Informal document **GRSP-52-20**
(52nd GRSP, 11 – 14 December 2012,
agenda item 21)

Proposal for corrections to ECE/TRANS/WP.29/2012/53 (GRSP) Proposal for a new Regulation on Child Restraints Systems

The first modifications proposed by the IWG CRS and presented to WP29 during the 158th WP.29, 13-16 November 2012, agenda item 4.13.3 as Informal document WP.29-158-22 are marked in purple or strikethrough characters.

Figure of paragraph 4.5., replace by the following figure:

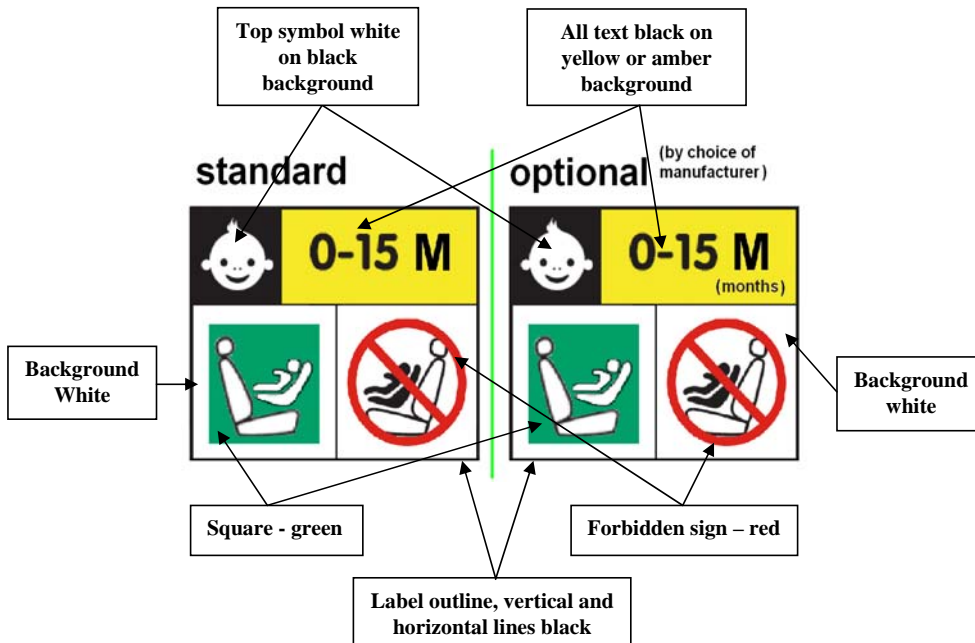
“Minimum label size 40 x 40 mm

Paragraph 6.3.5., amend to read:

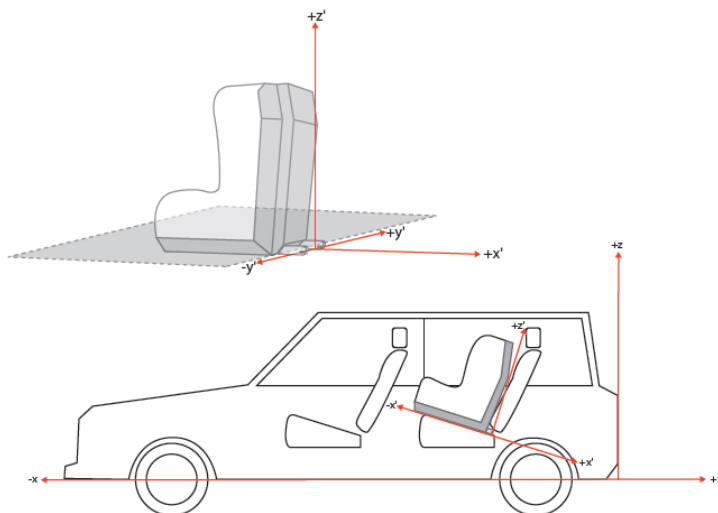
6.3.5. i-Size Child Restraint System support-leg and support-leg foot requirements
i-Size Child restraint systems fitted with support-legs must comply in all positions of use (e.g. in case of length adjustable attachment, base, etc. the

shortest and longest position) with the geometrical provisions defined in 6.3.5. and its subparagraphs.

Compliance with the requirements specified in paragraphs 6.3.5.1. and 6.3.5.2. may be verified by a physical or computer simulation.

The geometrical requirements in paragraphs 6.3.5.1. to 6.3.5.4. are referenced to a coordinate system, whose origin is located centrally between the two ISOFIX attachments and on the centreline of the corresponding ISOFIX anchorage system.

The orientation of the axes of the coordinate system is referenced to the child restraint fixture(s):

- (a) The X'_z axis shall be parallel to the Child Restraint Fixture (CRF)¹ bottom surface and in ~~to~~ the median longitudinal plane of the CRF;
- (b) The Y'_z axis shall be perpendicular to the median longitudinal plane;
- (c) The Z'_z axis shall be perpendicular to the CRF bottom surface.

In fulfilling the requirements of this section, the Child Restraint System shall be installed in accordance with the user manual of the Child Restraint System. The storage position of the support-leg is excluded from these requirements."

Figure 1
Side view of the support leg dimension assessment volume

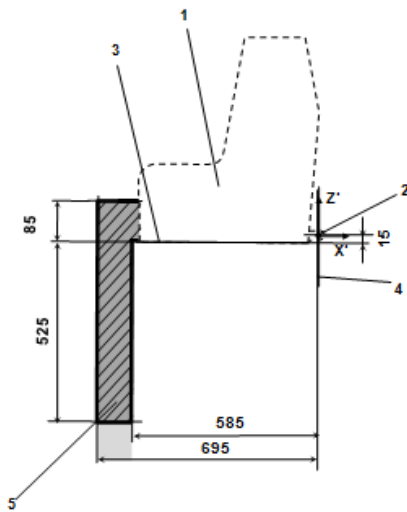
Annex 19, figure 1 to figure 3., amend to read :

1. Child Restraint Fixture (CRF)
2. ISOFIX low anchorages bar
3. Plane formed by the bottom surface of the CRF, which is parallel to and 15 mm below the X'_1 - Y'_1 plane of the coordinate system
4. Z'_1 - Y'_1 plane of the coordinate system
5. Upper part of the support-leg dimension assessment volume, which shows the dimensional limitations in X'_1 and Y'_1 direction, the upper height limit in Z'_1 direction, as well as the lower height limitation in Z'_1 direction for rigid, not in Z'_1 direction adjustable support leg components

1. Drawing not to scale.
2. Volumes (5 and 6) are defining the maximum limits of the support leg and its foot. No parts of the CRS shall exceed these limits in any position of adjustment when in use configuration.

Figure 3
Side view of the support leg foot assessment volume

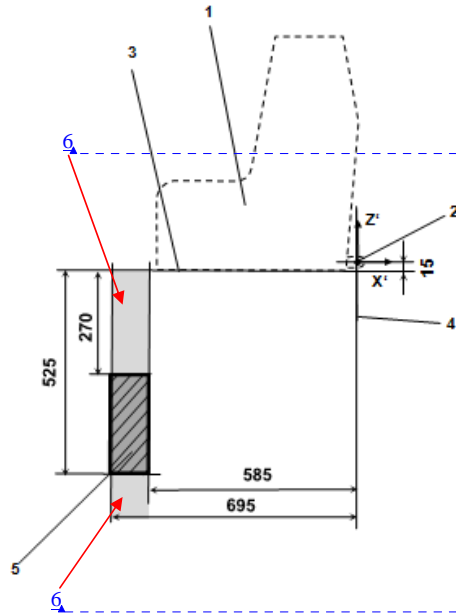
1. Child Restraint Fixture (CRF)
2. ISOFIX low anchorages bar
3. Plane formed by the bottom surface of the CRF, which is parallel to and 15 mm below the X-Y plane of the coordinate system
4. Z-Y plane of the coordinate system
5. Support-leg foot assessment volume, which shows the required adjustment range of the support-leg foot in Z directions, as well as the dimensional limitations in X and Y direction
6. Additional volumes shows the additional permissible adjustment range in Z direction for the support-leg foot
